Product Change Notification

Product Group: OPT/Wednesday February 19, 2025/PCN-OPT-1381-2025-REV-0

Alternative die bond paste for UV-LEDs

Details to PCN HN-1381-2025 Alternative die bond paste for UV-LEDs

VLMU351.-365-130 (also representative for VLMU35A10-...-120 series):

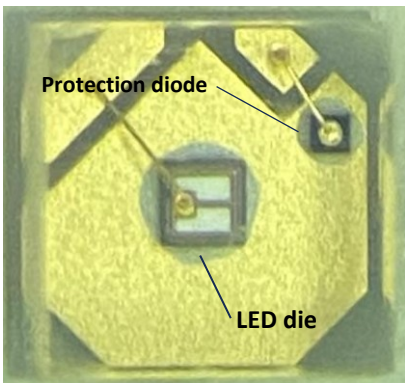
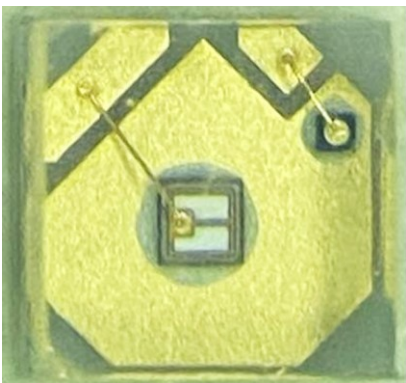
Current silver epoxy	New silver epoxy

Drift Charts VLMU351.-365-130:

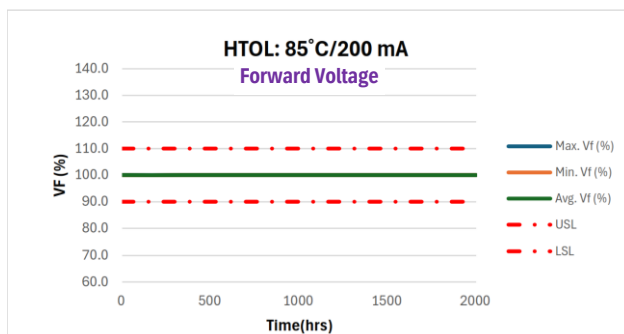
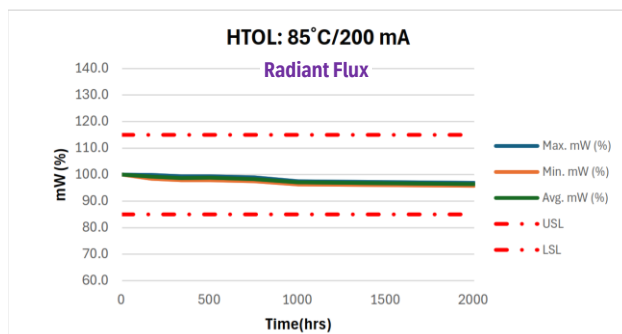
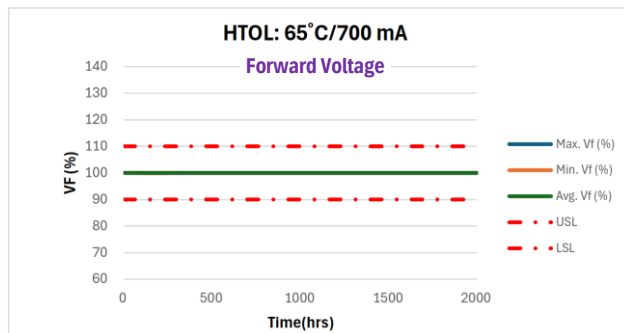
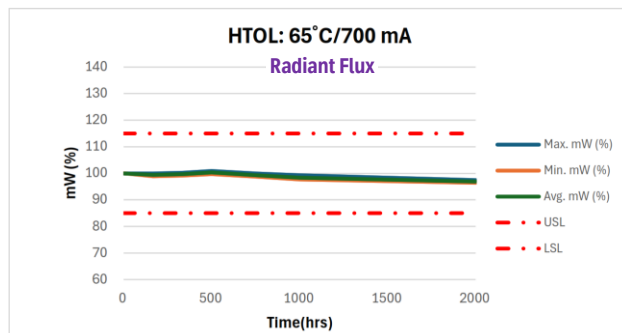
Qualification Results VLMU351.-365-130:
